Impact on LLWR Fleet of TC01 and TC03 Containers

Post – 1st July 2014 manufactured containers – CSC Plate requirements in accordance with 2017 Regulations

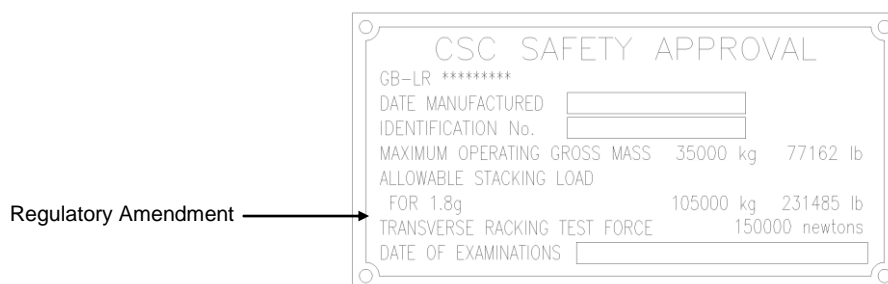
The Safety Convention Regulations 2017 directs the Safety of Containers (CSC) Plate must read with 'Transverse racking test force' in Newtons. (See image below)

This key regulatory change invokes a need to replace CSC Plates.

1. Affected TC01 Containers residing in UK, that are to be transported to LLWR for final disposal prior to their ACEP re-inspection date – no action required.
2. Affected Containers residing abroad - require the CSC plate changed to meet the new regulations, prior to being prepared for transporting to UK.
3. Affected Containers that are intended to remain on re-use system post next ACEP re-inspection date – require conversion to TC01R and the CSC Plate changed to meet the new regulations.

Upon receiving the replacement CSC Plate, check the identification number aligns to the package serial number. Remove old CSC plate, by drilling out rivets. Affix the replacement CSC Plate with “advel” monobolts (supplied) and apply SILFIX HM Clear Silicone Sealant to the upper edges of the plate. Discard the old CSC plate.
